LETTER REPORT

UH-1 HELICOPTER SHELTERS

SUBJECT: Letter Report of Evaluation - UH-1 Helicopter Shelters  
(IA-109.0)

FIGURE 3. Top section of bent main pole.

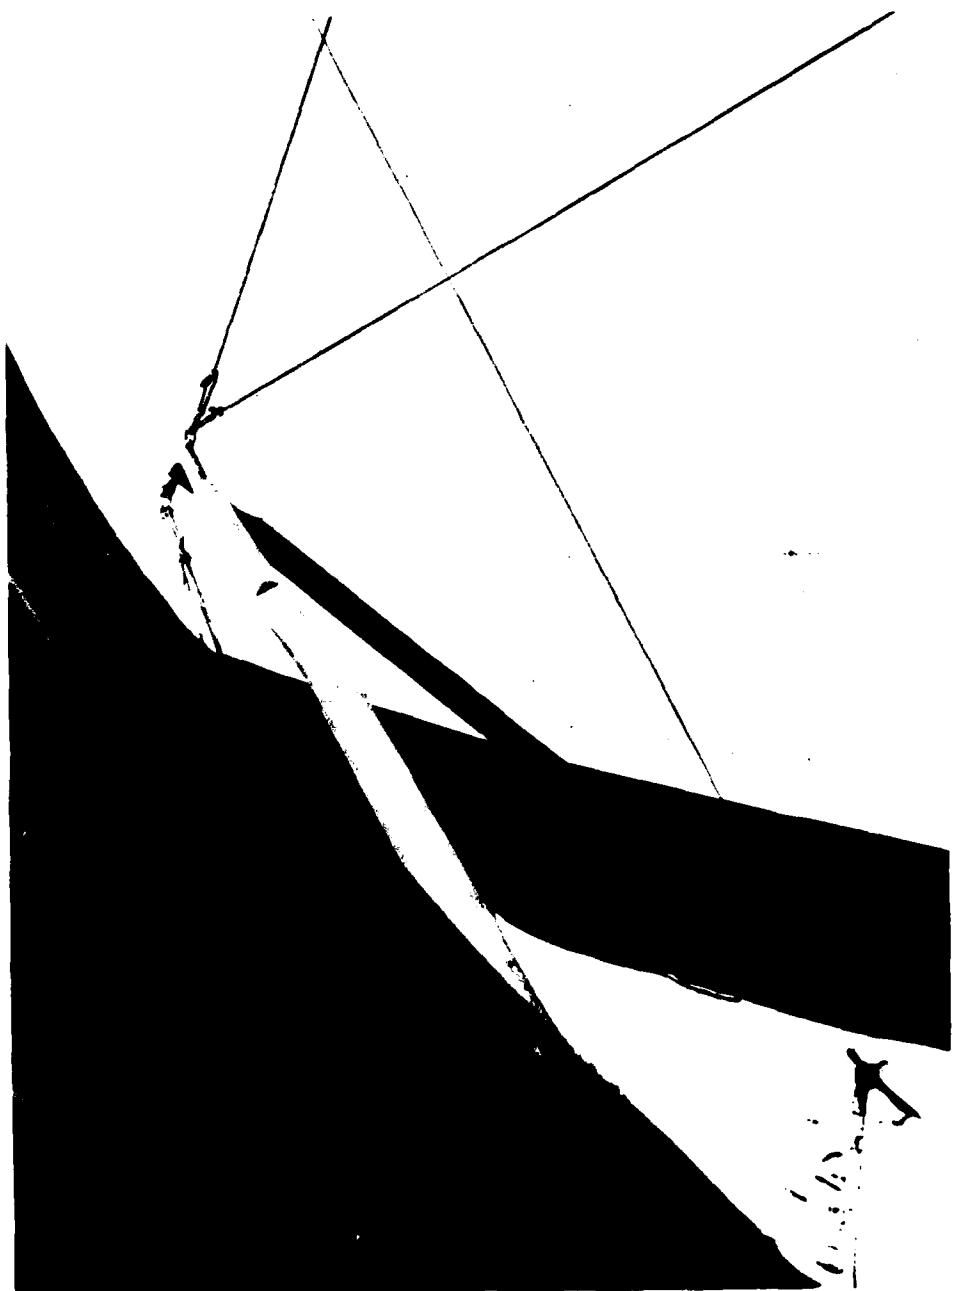
- f) The shelter was easy to erect or strike and could easily be loaded in a UH-1 helicopter although this was not evaluated.
- g) During installation the top section of the main pole bent approximately 3 feet from the top.

- j. There was no method to close the ends of the shelter other than the mosquito netting.
- k. The top section of the support pole bent during installation.
